INDIANA DEPARTMENT OF TRANSPORTATION

APPROVED MINUTES

August 20, 2009 Standards Committee Meeting

MEMORANDUM

E 805-SGFB-03 PEDESTAL MOUNTED SOLAR POWERED WARNING SIGN FLASHING BEACON ASSEMBLY (REVISED DRAFT)

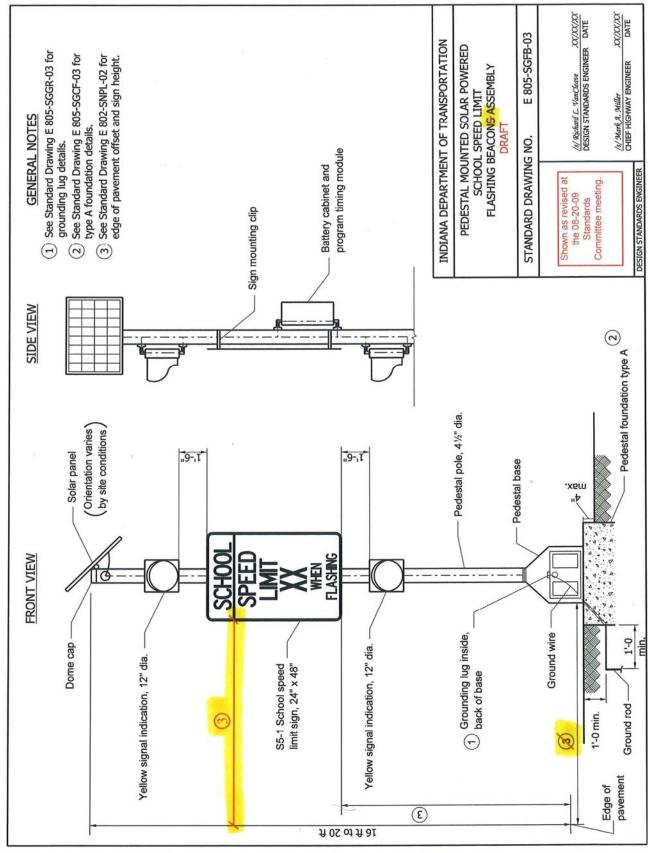
Due to the increasing use of solar-powered flashing beacons in rural areas, the district traffic engineers requested that a specification and standard drawing be developed for this type of traffic control device.

The proposed solution involves two standard drawings and revisions to Section 805 of the Standard Spec ifcations.

The proposed Standard Drawings are 805 SGFB 03 and 805 SGFB 04. Four other relevant Standard Drawings are, 802 SNPL 02, 805 SGCF 03, 805 SGGR 03, and 805 SGCO 05.

COMMENTS: It was determined that the provision for solar powered flashers will be incorporated into 805-T-169 Traffic Signals Recurring Special Provision. Final provision was a handout from Joseph Bruno and was revised at the meeting.

Copy of the Revised 805-T-169 Traffic Signals Recurring Special Provision, with changes highlighted in yellow, is included in these minutes.
